Levee Improvement District No. 19 System Review – Phase 1 Fort Bend County, Texas

Project No. 6312345825

May 31, 2018

Figure 4 - Typical Levee Cross Section

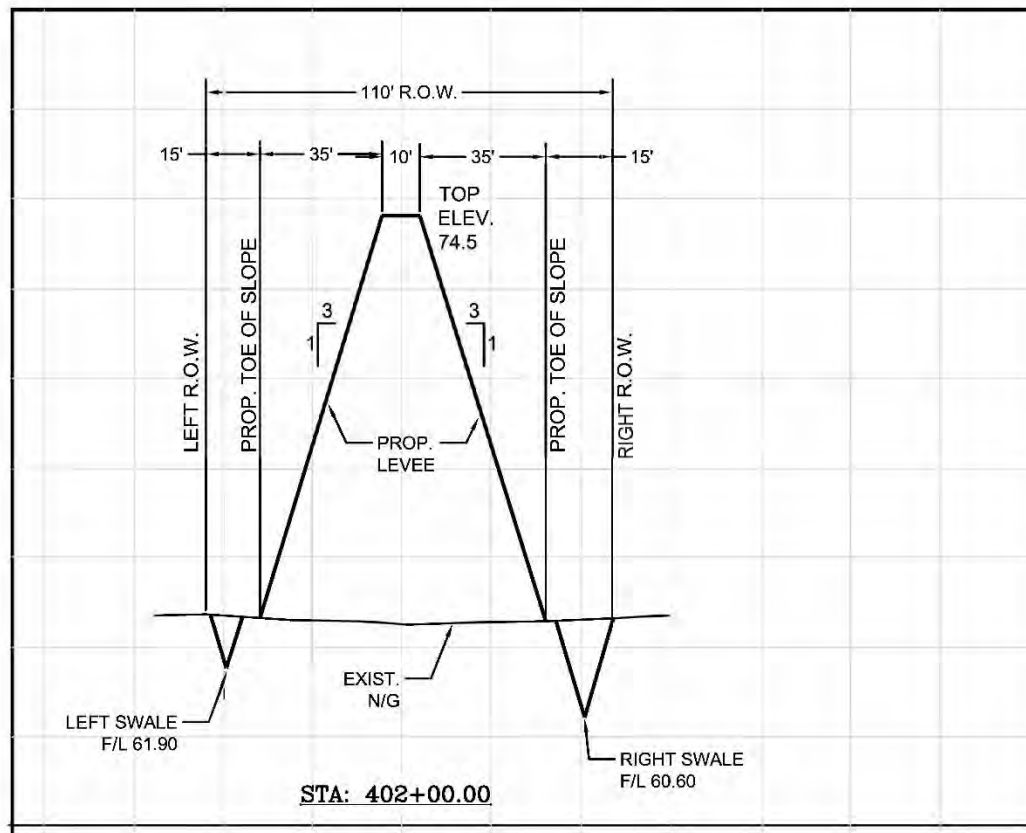
In reviewing the provided information, it was observed and confirmed that the updated FEMA data provided in the Flood Insurance Study released in 2014 was obtained and incorporated in the design of the levees. In accordance with applicable standards at the time of design, the levees were designed with a minimum slope of 1 vertical to 3 horizontal and a crest width of at least 10'. The right-of-way for levee construction cross-sections measured 110', with a minimum easement of 10' beyond the toe of the levee to be kept clear of obstructions such as structures and woody vegetation, though this easement exceeds the minimum 10' width in many cases. A typical cross section taken from the Record Drawings is shown in Figure 4.

Based on these conditions, it is our opinion the levee was designed and constructed in accordance with the aforementioned applicable standards in effect at the time of LID 19 creation. With respect to levee design and construction, Tables 2 through 4 summarize the compliance with individual requirements.

Figure 5 - Brazos River Flood Profiles from NFIP-FIRM 2014

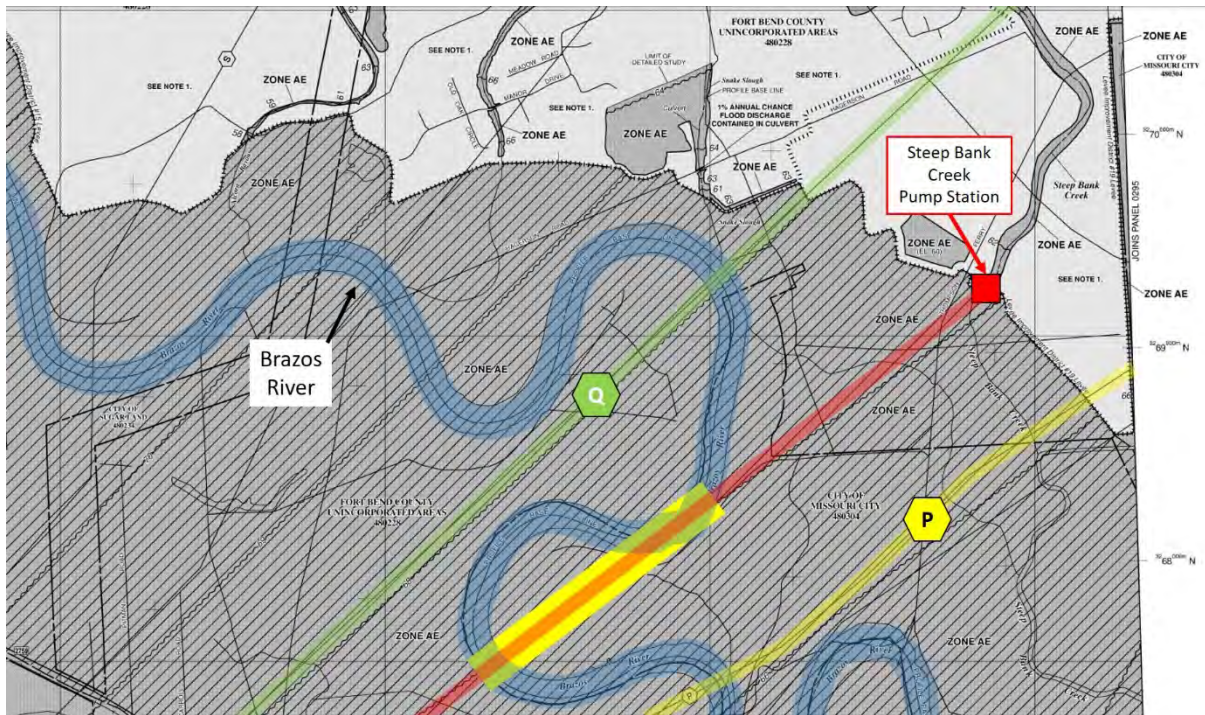
1. Find the location of the pump station outfall along the Brazos River Floodway between profiles "P" and "Q" using the updated FIRM maps (Figure 5). In this location the Brazos River crosses the Steek Bank Creek profile in two locations creating a range of flow rate values.

Figure 6 - FBC-DCM 2011, Figure 7-1-3

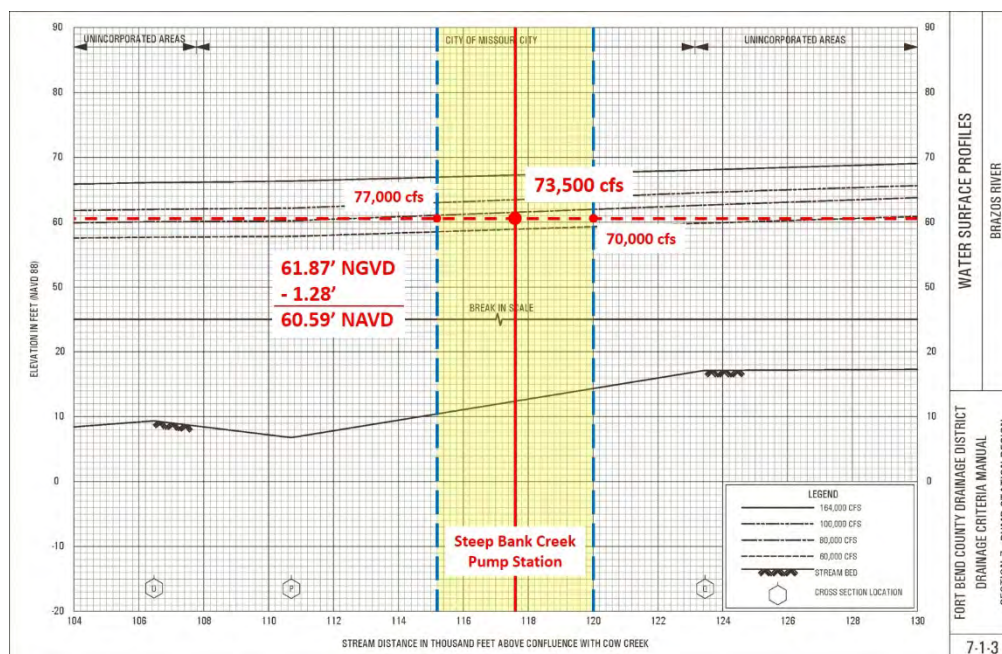
2. To determine this range, use the system's maximum ponding elevation of 61.87' NGVD 29 which converts to 60.59' NAVD 88. Apply this elevation in the location of the pump station in Figure 7-1-3 from the 2011 FBC-DCM and the corresponding flow rate values range from approximately 70,000 cfs to 77,000 cfs with the midpoint being 73,500 cfs, as demonstrated in Figure 6.

Figure 7 - FBC-DCM 2011, Figure 7-2

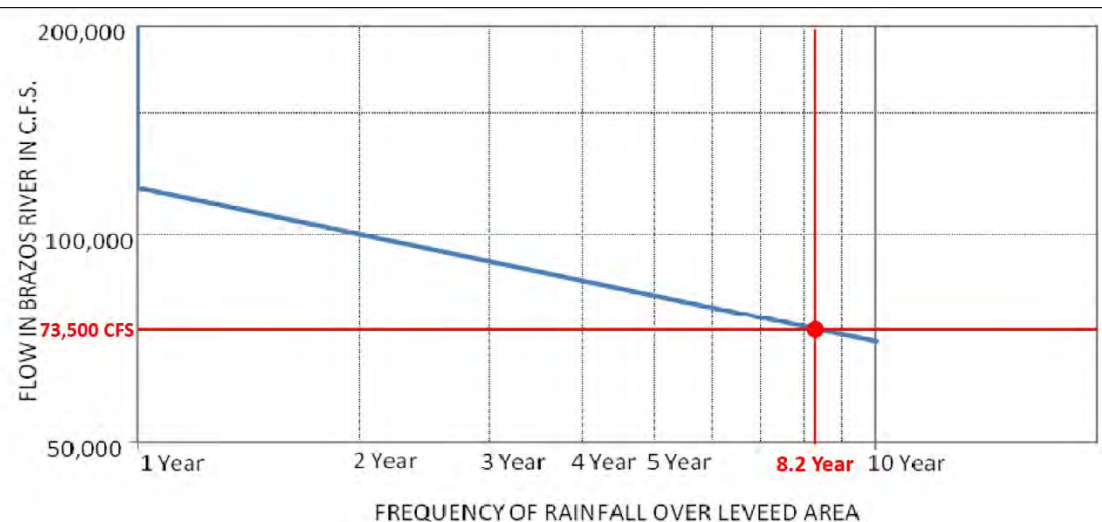
- Using this midpoint flow rate of 73,500 cfs in the Brazos River, the frequency of rainfall over the leveed area for coincidental events is determined to be an 8.2-year event, as shown in Figure 7 below.

Figure 8 - FBC-DCM 2011, Figure 7-3

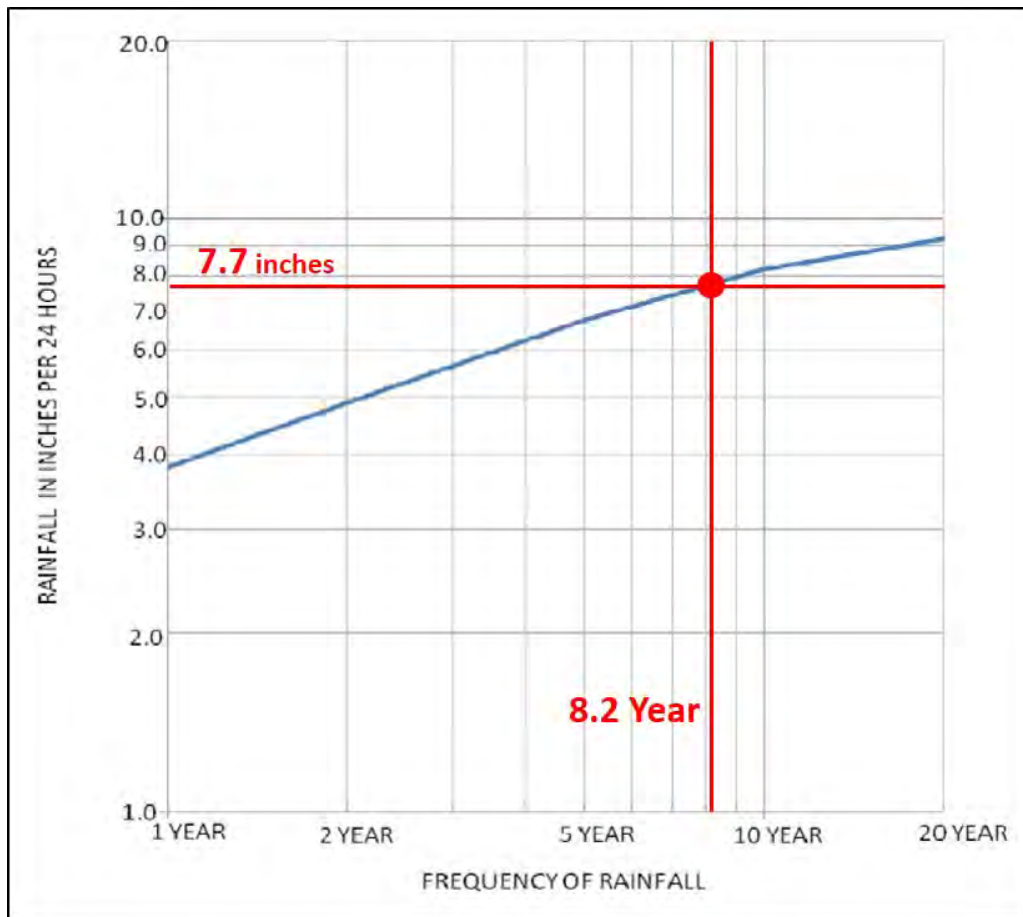
- Applying this rainfall frequency to (Figure 8), the inches of rainfall in 24 hours over the leveed area is determined to be 7.7 inches.

Using this rainfall information, new hydrographs were created representing the updated rainfall intensity and imported into the ICPR model. Several iterations were performed, adjusting the pumping needs until the maximum ponding elevation was maintained. This resulted in a pumping requirement of approximately 100,000 gpm. Consequentially, the current pump station of 60,000 gpm does not meet this requirement.
